City of Fredericksburg

Historic Review Board Meeting Agenda
Tuesday, March 11, 2025 ~ 5:30 PM
New City Hall at East Campus
2818 E. U.S. Hwy. 290
Fredericksburg, Texas 78624

**HISTORIC REVIEW BOARD
MEETING MINUTES
February 11, 2025
5:30 PM**

EXISTING FRONT ELEVATION
SCALE 1/4" = 1'-0"

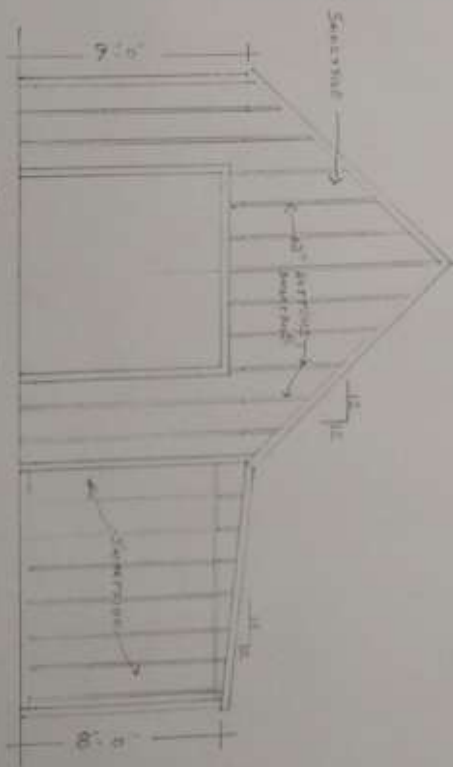
Please provide photos of all 4 sides of the building.

Please provide a material list to include the siding, roof, window and door material of the proposed new construction.

507 W Main – Updated Renderings

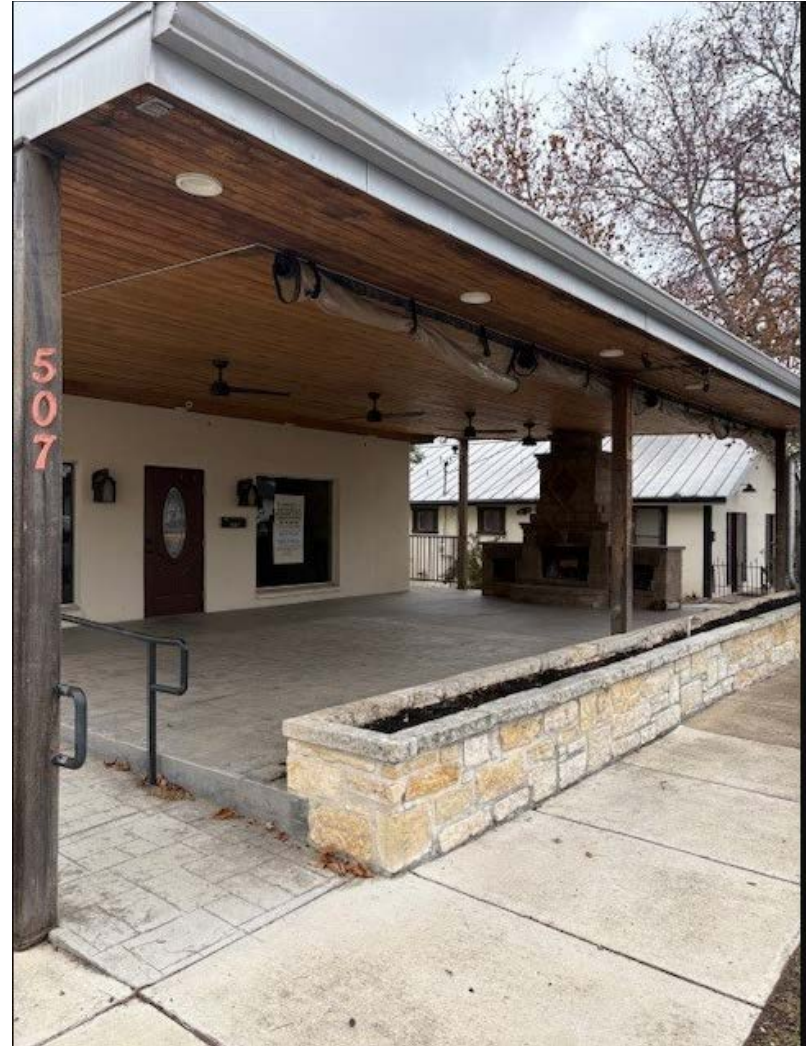
John Tomlin stated that the intent was to place the glass behind the rock planter wall. That it was set back at least 5 or 6 feet. The rendering wasn't a great representation of the actual finished product.

Todd Eidson mentioned that a better rendering with more detail would be helpful.

Todd Eidson mentioned that the applicant spends a little additional money on better rendering so that it showed the rock wall planter, maybe less divisions in the glass. Work with someone to produce a more detailed rendering.

The Historic Review Board considered this application on Tuesday, February 11th and asked the applicant to provide more accurate renderings that depicted the exact location of the glass enclosure as well as the request to depict the existing stone planter. The applicant has since provided updated renderings.
